INSPECTION REPORT
Sedimentation Structure
J16-F
Kayenta Mine
Navajo County, Arizona
for
PEABODY COAL COMPANY

Dames & Moore
10139-011-22

EXISTING
MAXIMUM CROSS-SECTION
A-A'
J16-F

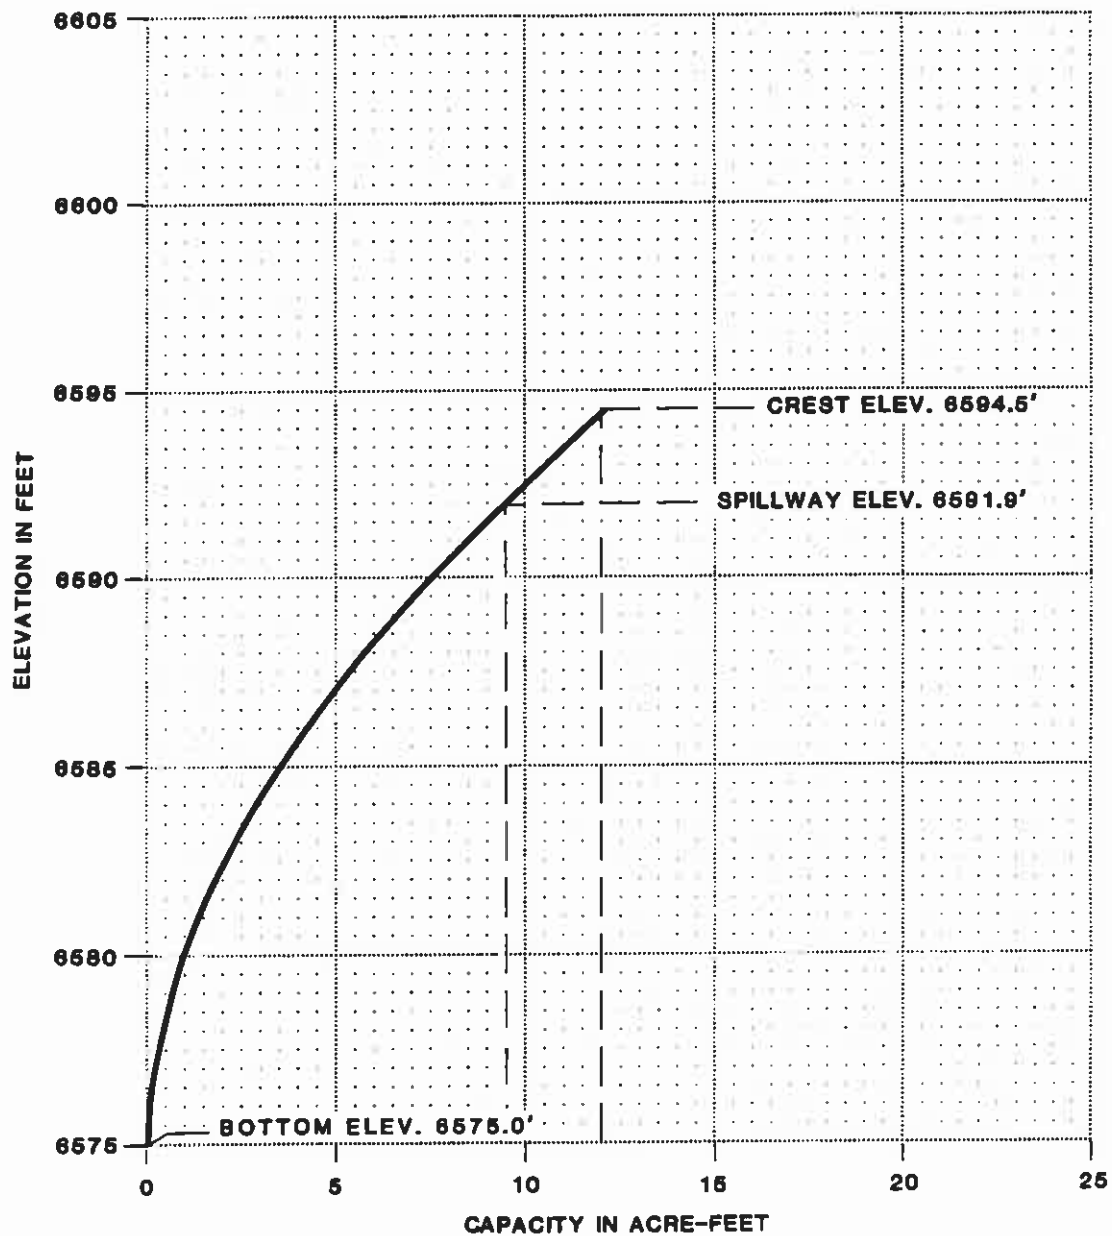
The inspection of Structure J16-F indicated that the only geotechnical problem is rill and gully erosion on the upstream and downstream slopes, the side slopes of the spillway channel and the left abutment. Correction of erosion is considered a periodic maintenance task and does not require remedial action. The crest and upstream slope of the

embankment are uneven and should be trimmed level and smooth, respectively, to prevent masking of future potential problems.

CHANNEL PROFILE B-B'
J16-F

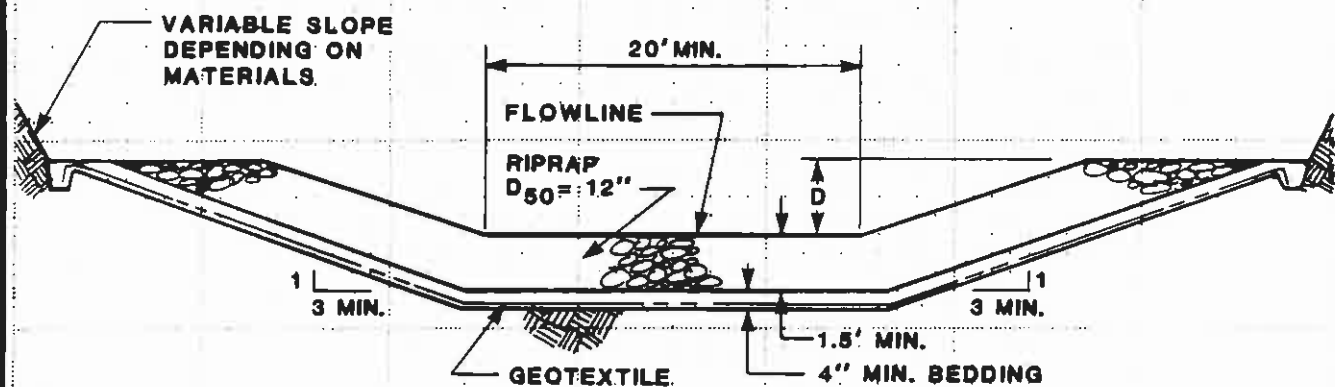
The storage capacity and spillway capacity of Structure J16-F are adequate. The outflow channel is protected with riprap but the spillway channel is not. The spillway channel should be protected against erosion using geotextile and riprap as shown in Plate 5. Plate 4 shows the existing spillway and outflow channel profile and Plate 5 shows the channel dimensions.
